**4395A-16**

# S E R V I C E N O T E

## Agilent 4395A Network/Spectrum/Impedance Analyzer

**Firmware upgrade to fix occasional rise in noise floor and the shift of measurement signal in frequency with SA mode.**

Fig.1 Peak observed with the indicated procedure.

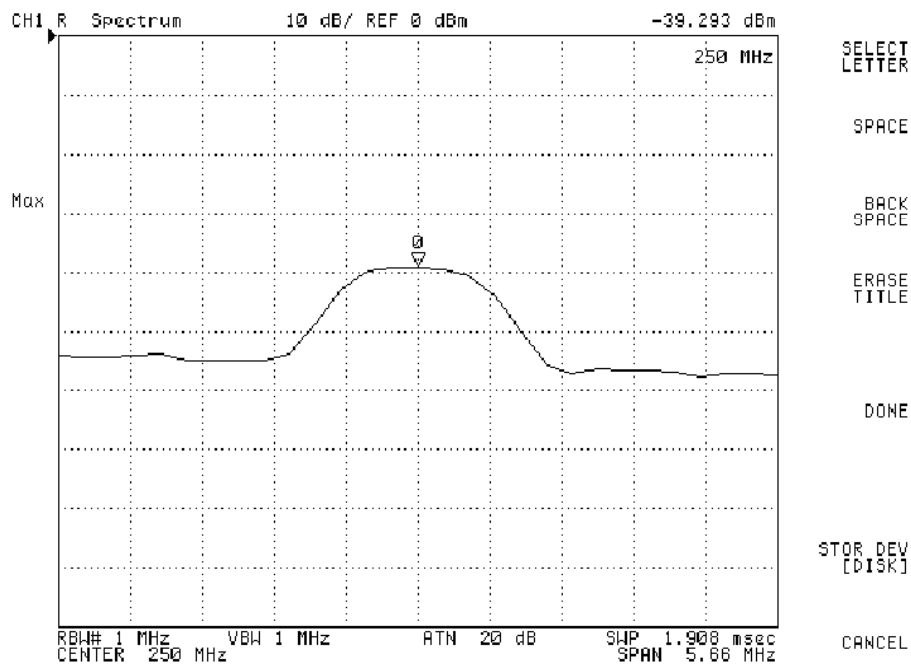
There are some units among the indicated serials that have a possibility of occasional rise in noise floor or occasional shift of measurement signal in frequency with SA mode.

- 1) Press [Preset]
- 2) Press [Meas] and set analyzer type to spectrum analyzer.
- 3) Set frequency to Center: 250 MHz, Span: 5.66MHz.
- 4) Press [Bw/Avg] and set RES BW to 1MHz.
- 5) Press [Display] and set DATA HOLD to MAX
- 6) Leave the unit running for an hour and confirm if a peak can be observed. See Fig.1 for the type of peak that can possibly be observed. Typically the peak is around  $-40\text{dBm}$ .  
If a peak is observed, upgrade the firmware to revision 1.10 or above.

To install the latest firmware, click “Software & Firmware Downloads” at below URL. Then click the heading in the column of Firmware Update and follow the firmware installation procedure to install the latest firmware.

Order firmware revision label 1.10. Detach the old firmware label on the rear panel of 4395A and attach revision label 1.10.
